COMMUNITY DEVELOPMENT DEPARTMENT REPORT

HEARING DATE: 7/14/2026
TO: Mayor & City Council
FROM: Sonya Allen, Associate Planner
208-884-5533
sallen@meridiancity.org
APPLICANT: Hawkins Companies
SUBJECT: Ustick Commercial and McUstick Subdivision
H-2025-0059 (CPAM); H-2026-0007 (AZ, PP)
LOCATION: 5900 W. Ustick Rd., in the southwest 1/4 of Section 33, T.4N., R.1W.

I. PROJECT OVERVIEW

USTICK RD. LANDSCAPE BUFFER SECTION

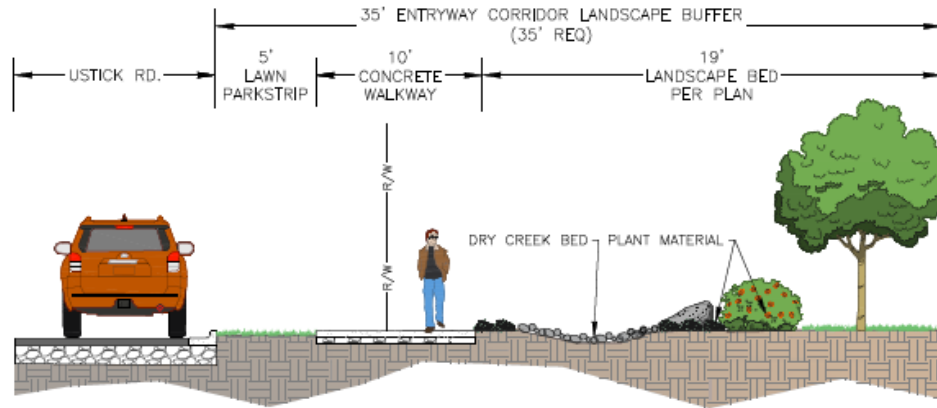
Landscaping must comply with the standards in UDC 11-3B-7C. **Lawn and other grasses requiring regular mowing shall comprise no more than sixty-five (65) percent of the vegetated coverage of a landscape buffer; calculations demonstrating compliance should be included on the plan.** Because W. Ustick Rd. is an entryway corridor, additional landscape design features are required within the buffer as set forth in UDC 11-3B-7C.3f. The additional design features consist of a dry creek bed with river rock and boulders as shown on the cross-section below and on the landscape plan below in Section VII.H.

- ii. Lawn and other grasses requiring regular mowing shall comprise no more than sixty-five (65) percent of the vegetated coverage of a landscape (street) buffer per UDC 11-3B-7C.3e; calculations or a note demonstrating compliance should be included on the plan.

- iv. Depict a 25-foot-wide buffer to adjoining residential land uses with landscaping per the standards in UDC 11-3B-9C.
 4. Additional design features consisting of a dry creek bed with river rock and boulders shall be included in the street buffer along W. Ustick Rd., an entryway corridor, as proposed, in accord with UDC 11-3B-7C.3f.

E. Conceptual Development Plan

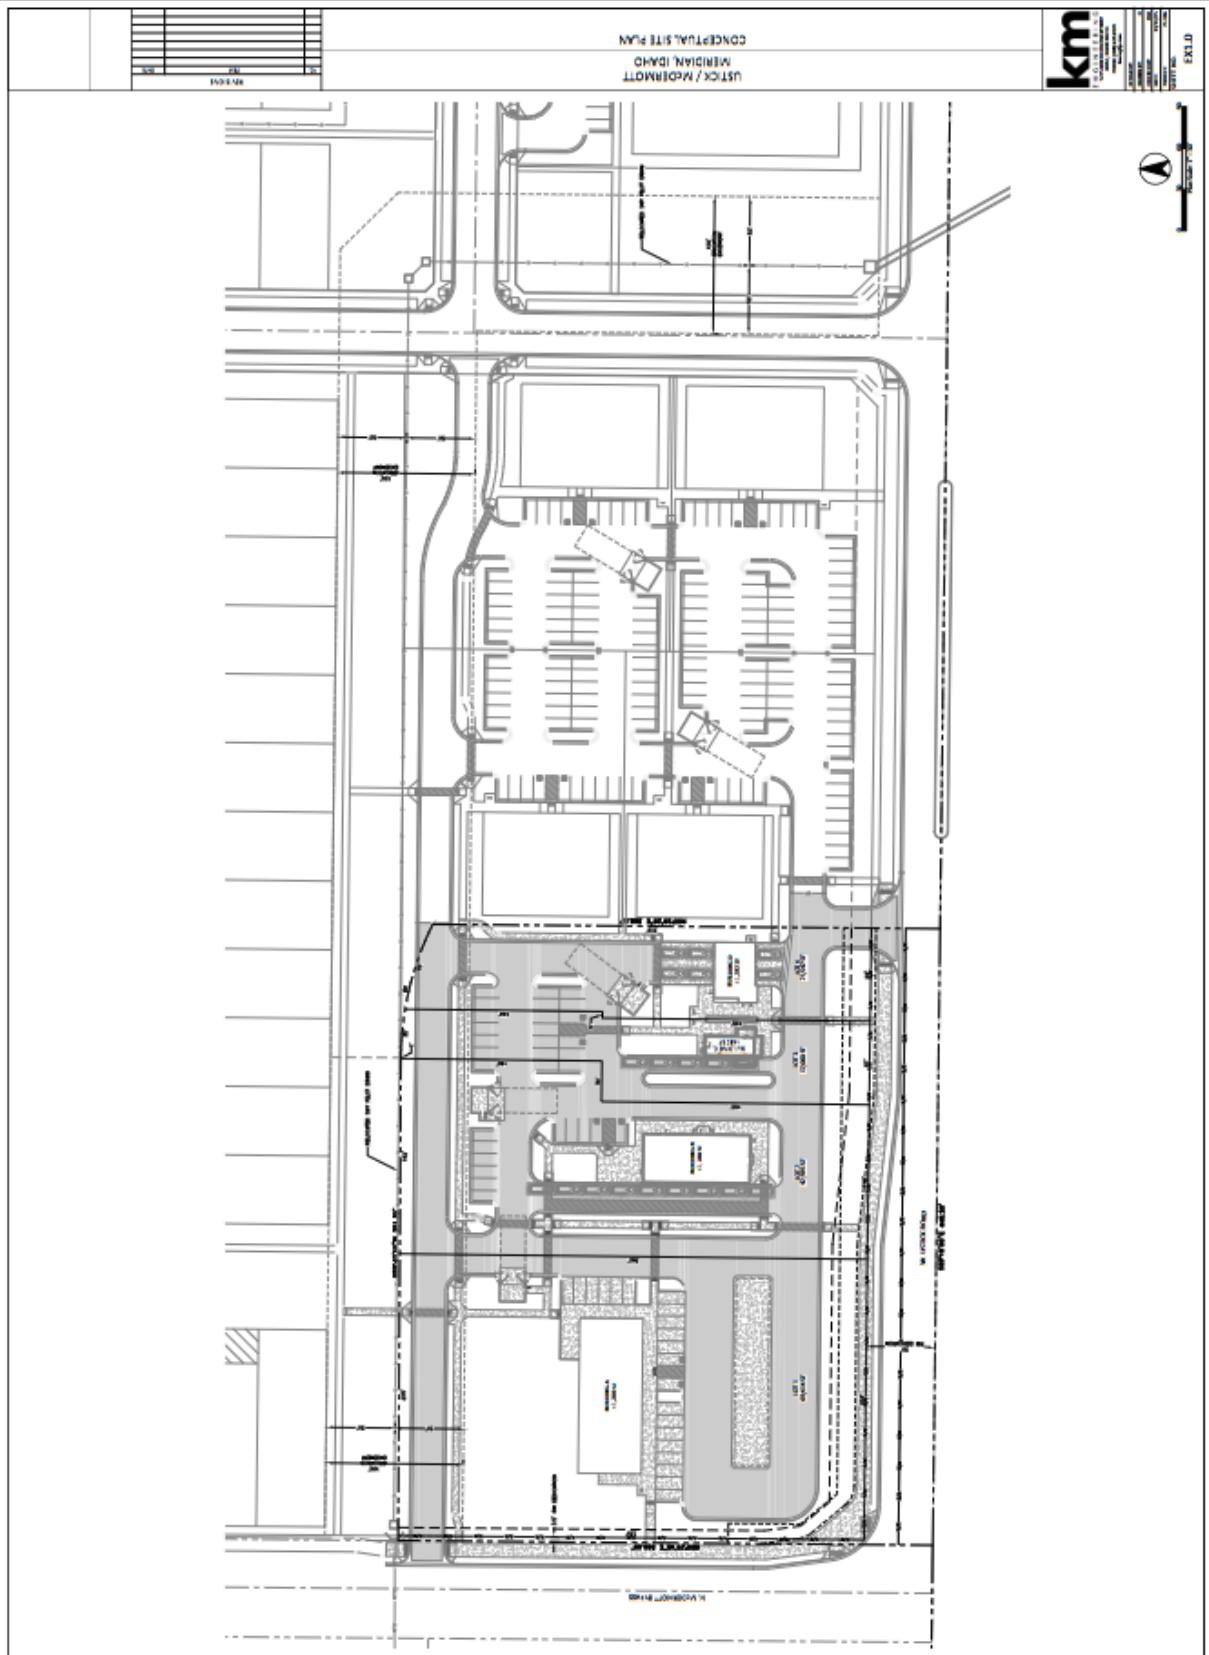
A conceptual development plan and building elevations are proposed with the annexation application that demonstrate how the site is proposed to develop with a convenience store/fuel sales facility, oil change facility, coffee shop, financial institution and/or other commercial uses as allowed in the proposed C-C zoning district. Four (4) building pads are proposed, two (2) of which have drive-through establishments.

The proposed development plan is entirely auto-oriented, which is not desired in such close proximity to the Ustick/McDermott interchange. This area is not intended for high volume trips and is to be protected from traffic conflicts, which are created by high traffic-generating uses, thus the reason the MDR FLUM designation was determined to be the most appropriate for this site and the Mixed Use – Interchange (MU-I) designation most appropriate for across the street to the west adjacent to the interchange.

The conceptual development plan depicts an interconnected network of walkways and drive aisles that promote pedestrian and vehicular mobility within the development and to the adjacent development to the east; a pathway is proposed to the future residential development to the north for pedestrian access and connectivity, no vehicular connectivity is proposed.

For lots with frontage on a public street, a minimum of thirty (30) percent of the buildable frontage of the property shall be occupied by building facades and/or public space per UDC 11-3A-19B.2b. A drive aisle is proposed along the frontage of the property adjacent to Ustick Rd., which separates the buildings from the street – parking is proposed at the rear of the buildings. **If the proposed development is approved, compliance with this standard is required. A revised conceptual development plan should be submitted that demonstrates compliance with this standard.**

2. Access (*UDC 11-3A-3, UDC 11-3H-4*):
One (1) full access is proposed via N. McDermott Bypass on the west side of the site at the north boundary; and one (1) right-in/right-out temporary access is proposed via W. Ustick Rd. at the east boundary of the site. The McDermott Bypass is currently under the jurisdiction of ITD but is expected to be turned over to ACHD at some point in the future. ITD has stated they won't support access via McDermott Bypass.

Staff is not supportive of an access via W. Ustick Rd. ACHD states that the TIS did not demonstrate a need for this driveway. Further ACHD, like City policy, requires access to be taken from lesser-classified roadways, which is McDermott Bypass; a collector roadway once under the jurisdiction of ACHD.

Drive aisle stubs are proposed to the property to the east but no vehicular connectivity is proposed to the future residential development to the north. **If approved, Staff recommends a drive aisle connection be provided to the north for interconnectivity with the residential neighborhood. Cross-access/ingress-egress easements are required between all lots in the subdivision and to adjoining properties either by recorded easement or as a note on the final plat as set forth in UDC 11-3A-3A.2.**

- iv. The site design shall comply with the site design standards in UDC 11-3A-19.B.2b, which require a minimum of thirty (30) percent of the buildable frontage of the property to be occupied by building facades and/or public space.

- v. Lot 1, Block 1 may operate 24 hours a day, 7 days a week.
 - vi. Access to W. Ustick Road is prohibited in accord with UDC 11-3A-3.
 - vii. Any future development of the site must comply with the City of Meridian ordinances in effect at the time of the development.

2. The final plat(s) shall include the following revisions:
 - i. Depict cross-access/ingress-egress easements between all lots in the subdivision and to adjoining properties either by recorded easement or as a note on the final plat as set forth in UDC 11-3A-3A.2.

H. Landscape Plan and Buffer Exhibit (date: 12/15/2025)

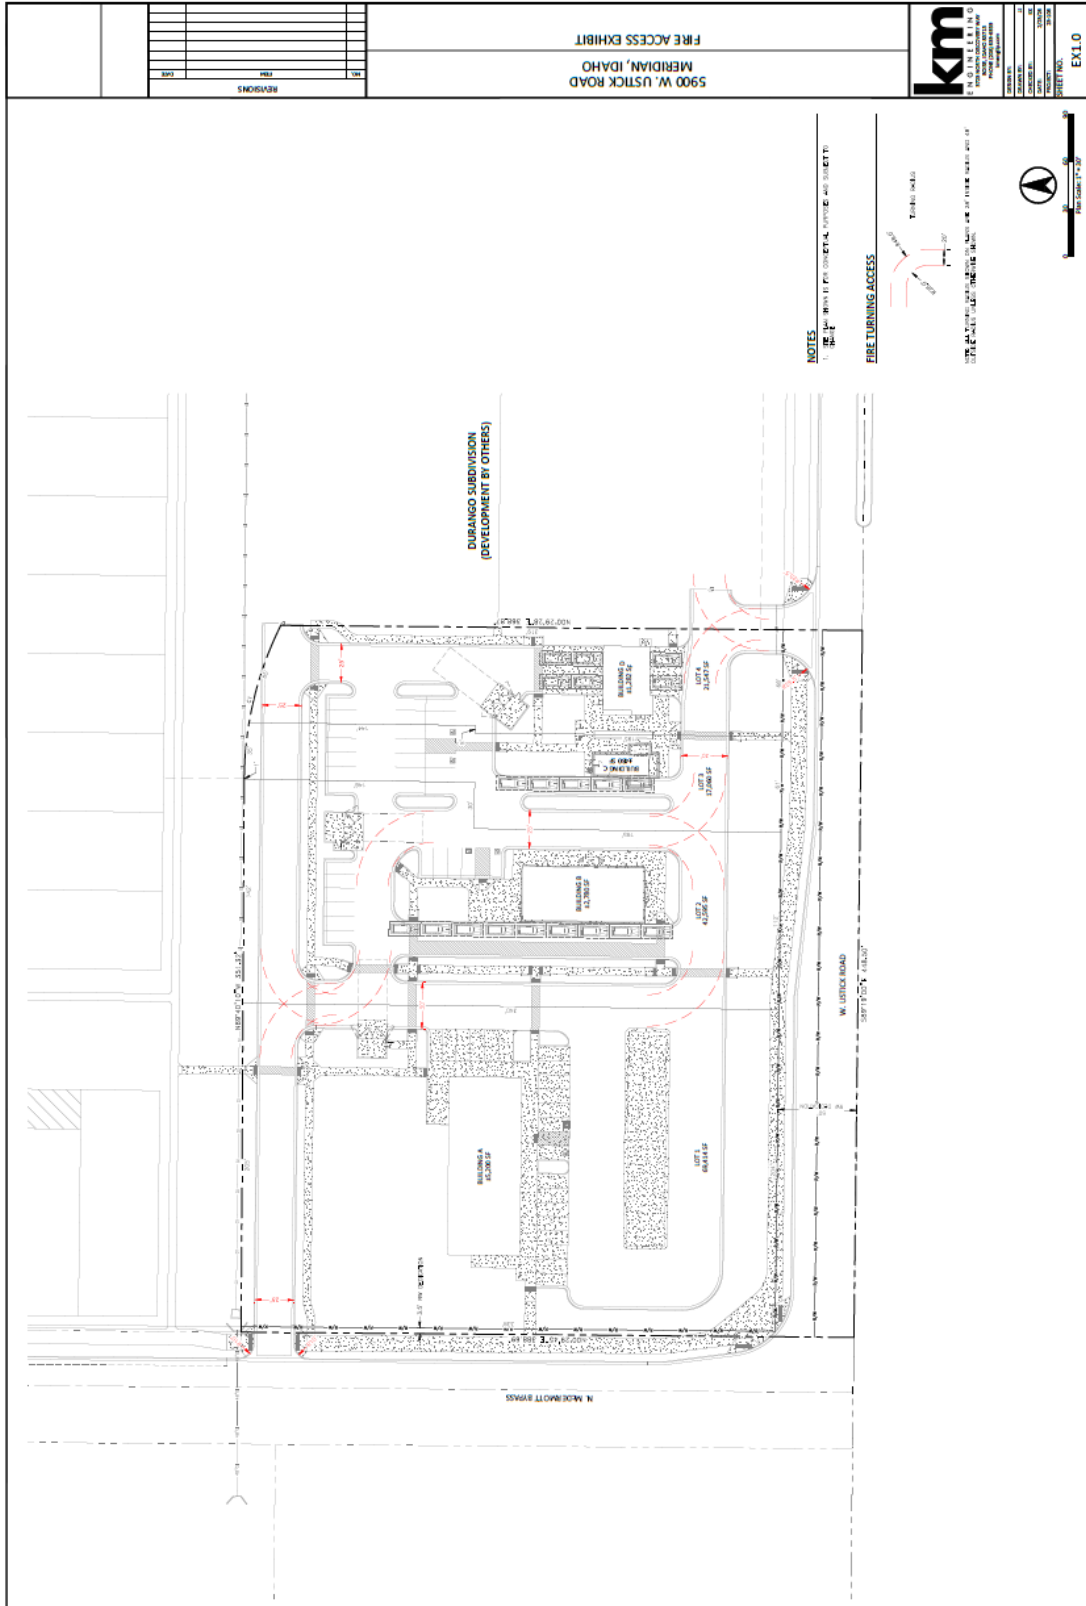
A minimum 25-foot-wide buffer is required adjacent to residential land uses in the C-C district in accord with UDC Table 11-2B-3 landscaped per the standards in UDC 11-3B-9C. Where the adjacent property is vacant, the FLUM designation determines use. Although no residential land uses currently exist on the adjacent property to the north and east, the FLUM designation on that property is MDR. With the pending Durango Subdivision application for that property, residential uses are proposed to the north and office uses are proposed to the east.

Because there is a 50' wide easement for the Sky Pilot Drain along the north property boundary, which prohibits trees/shrubbery, the buffer should be placed outside of the

easement. **The width of the buffer may be modified by City Council at a public hearing with notice to surrounding property owners if requested by the Applicant.**

There are existing trees on the site that will be removed with development. **Mitigation should be assessed prior to removal of any trees from the site and information should be included on the landscape plan that demonstrates compliance with the standards in UDC 11-3B-10C.5.**

3. The landscape plan submitted with the final plat application(s) shall include the following revisions:
 - i. Where pedestrian pathways are proposed from perimeter sidewalks to the main building entrances, pathways shall be distinguished from vehicular driving surfaces through the use of pavers, colored or scored concrete, or bricks, per UDC 11-3A-19B.4b.

- iii. Mitigation information shall be included for all existing trees four-inch caliper or greater that are removed from the site as set forth in UDC 11-3B-10.
